COUNCIL ASSESSMENT REPORT

Panel Reference	2019SNH020
DA Number	68/19
LGA	North Sydney
Proposed Development	The construction of a 31 storey commercial office building at No. 173 Pacific Highway and alterations and additions to the existing building at No. 116 Miller Street including a through site link between the Pacific Highway and Miller Street frontages of the site
Street Address	173 Pacific Highway and 116 Miller Street, North Sydney
Applicant/Owner	Maville Investment Trust, Maville Bay Pty Ltd
Date of DA lodgement	13 March 2019
Number of Submissions	Two (original proposal); Zero (amended proposal)
Recommendation	Approval
Regional Development Criteria (Schedule 4A of the EP&A Act)	Capital Investment Value (CIV) of greater than \$30 million
List of all relevant s4.55(1)(a) matters	SREP (Sydney Harbour Catchment) 2005 SEPP 55 - Contaminated Lands SEPP Infrastructure 2007 North Sydney LEP 2013 <ul style="list-style-type: none"> • Zoning – B3 Commercial Core North Sydney DCP 2013

List all documents submitted with this report for the Panel's consideration	Conditions Plans
Report prepared by	Luke Donovan, Senior Assessment Officer, North Sydney Council
Report date	7 November 2019

Figure – Aerial photograph and mark up prepared by RMS and submitted with their comments – Source: RMS

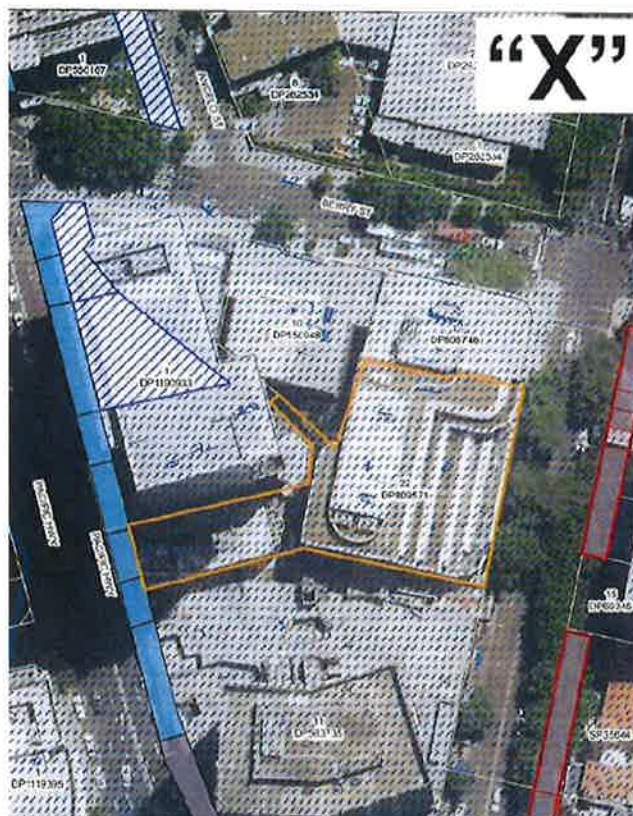
RMS raised no objections however advised that they have previously acquired a strip of land for road along the Pacific Highway frontage of the subject property as shown by blue colour on the Figure below.

RMS advised in their comments dated 17 October 2019 that *“the applicant is requested to remove any pedestrian awnings located within Roads and Maritime owned land. Updated plans clearly displaying the removal of the awning should be re-submitted to North Sydney Council for review and approval”*.

Comment: As part of RMS’s conditions they have requested the deletion of the awning along the Pacific Highway frontage of the site. RMS have not provided any specific reasons for the deletion of the awning other than potential future road widening. It is noted that the buildings to the north at 177 Pacific Highway and to the south at 100 Miller Street have awnings along the Pacific Highway frontages of these sites. These awnings are similarly located within the area marked in blue on the aerial photograph attached to the RMS comments/conditions. The awning would provide a significant public benefit to the proposed development as it would provide weather protection and improved pedestrian comfort. An awning that can be detached from the main building should be provided along the Pacific Highway frontage to the site. Should RMS widen Pacific Highway in the future, as flagged in their comments, this awning could easily be removed to accommodate the widening through a deed of agreement provided to the RMS.

Figure – Extract from the NSLEP 2013 height of building map

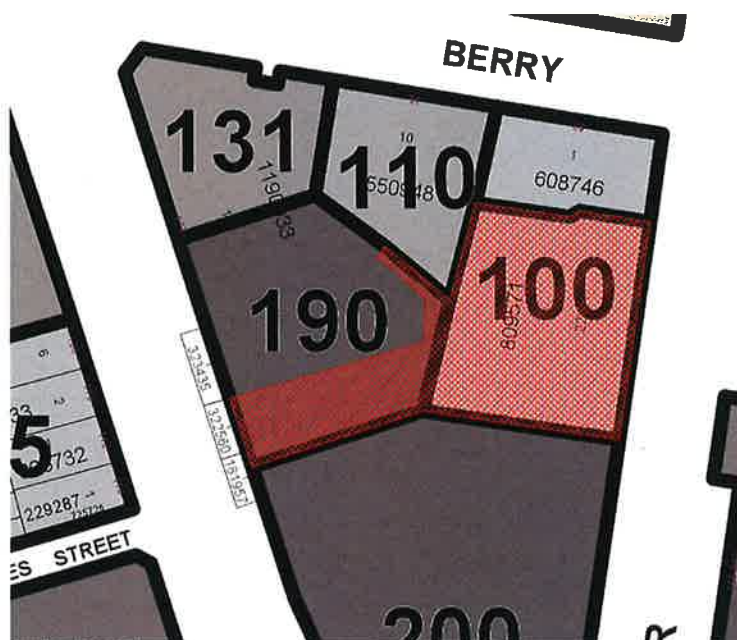
Height (Cl. 4.3)	173 Pacific Highway The proposed height of building over the western part of the site at 173 Pacific Highway is RL190 (AHD). The amended proposal removed the portion of the building that cantilevered over 116 Miller Street which has a maximum height of building of RL100.	RL 190 AHD (<i>Western part of the site at 173 Pacific Highway</i>) RL 100 AHD (<i>Eastern part of the site at 116 Miller Street</i>)	Yes
	116 Miller Street The application does not seek a change to the height of the existing building over the eastern part of the site at 116 Miller Street. The maximum height of this existing building is RL100.627

Figure - Sky view assessment – looking south at the corner of Pacific Highway and Berry Street
Source: Woods Bagot

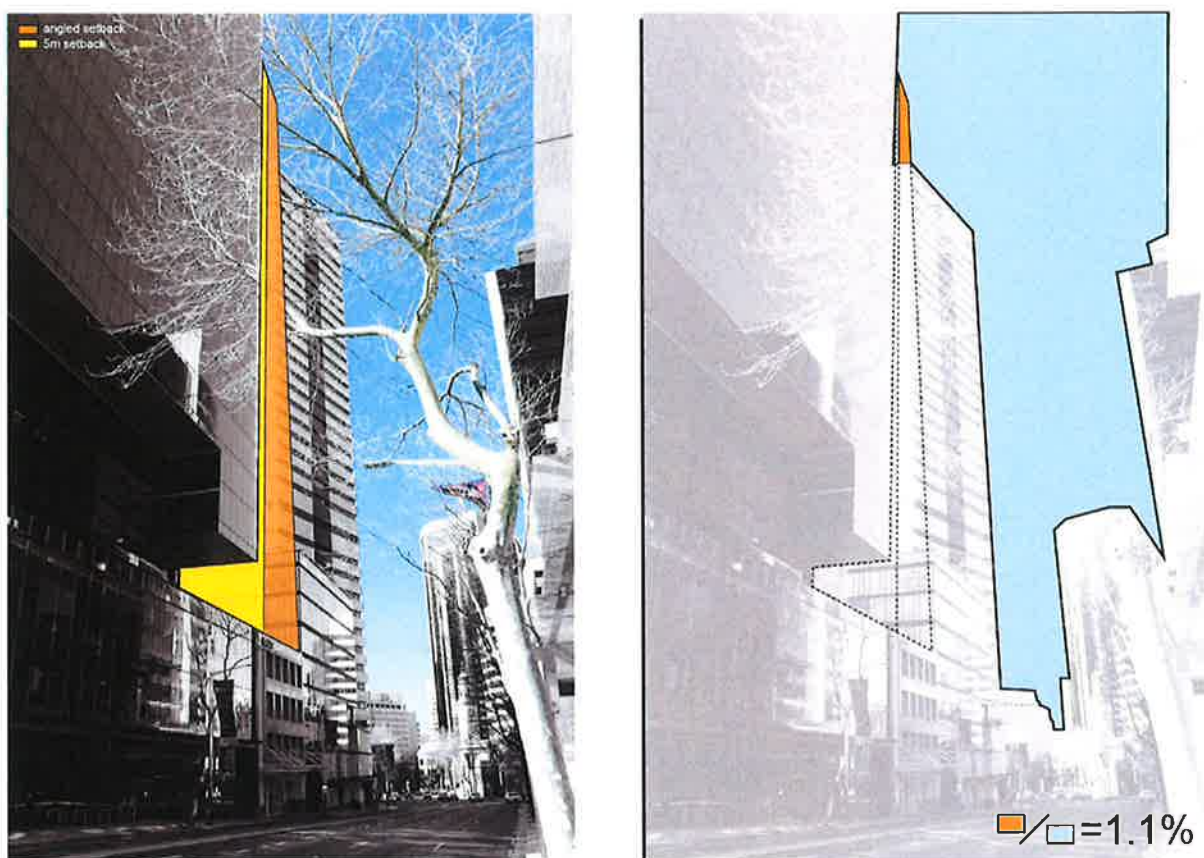
The subject site is within the Central Business District which falls within the North Sydney Centre Planning Area. The proposal is generally consistent with the character statement other than the non-compliances with 5m weighed (average) above podium setback to Pacific Highway. The proposal provides a 3.8m above podium setback where the building adjoins 177 Pacific Highway to the north and a zero setback where the building adjoins the Vibe Hotel to the south. This results in an angled façade above the podium fronting Pacific Highway. The weighed or average above podium setback would therefore be 1.9m.

- The buildings to the north of Berry Street do not have a consistent and or compliant above podium setback to Pacific Highway;
- The Applicant has demonstrated that the proposed setback to the Pacific Highway will not significantly alter the sky views currently available on the Pacific Highway frontage of the site. (refer to Figure below)

- The Applicant has further advised that “*requiring an additional 1.2m setback in the north western corner of the site would also restrict the functionality of the building and the office floorplate. The provision of a linear core on the northern side of the building has been designed to be as efficient as possible, however, warrants extensive length which places pressure on the edges of the building. As observed, the core occupies much of the northern wall and setbacks have been adopted to reflect this. Stepping back the building further in this corner would require significant*

amendments to the building core which would impact accessibility, structural changes, and the overall functionality of the building.”
